AMENDMENT NO. 1 AUGUST 1993
TO
IS 6702 : 1991 MORSE TAPER REDUCTION SLEEVES –
SPECIFICATION
(*First Revision*)

Table 1 Dimensions for Morse Taper Reduction Sleeves
(*Clause 4*)

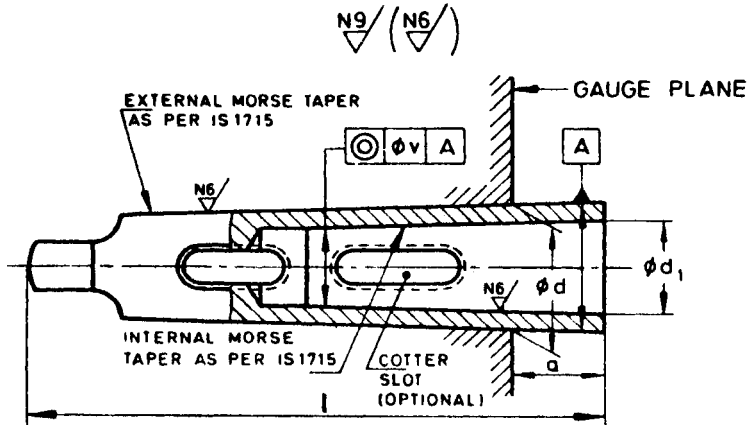
(*Page 2, Table 1*) — Substitute the following for the existing table:

Morse Taper No.	External Taper			Internal Taper		<i>v</i> , Max	
	<i>d</i>	<i>l</i>	<i>a</i>	Morse Taper No.	<i>d</i> ₁	Grade 1	Grade 2
2	17.780	92	17	1	12.065	0.008	0.015
3	23.825	99	5	1	12.065	0.008	0.015
		112	18	2	17.780		
4	31.267	124	6.5	(1)	12.065	0.008	0.015
				2	17.780		
		140	22.5	3	23.825		
5	44.399	156	6.5	(1)	12.065	0.010	0.020
				(2)	17.780		
				3	23.825		
		171	21.5	4	31.267		
6	63.348	218	8	(1)	12.065	0.010	0.020
				(2)	17.780		
				3	23.825		
				4	31.267		
				5	44.399

NOTE — The reduction sleeves with internal tapers given within brackets are non-preferred.
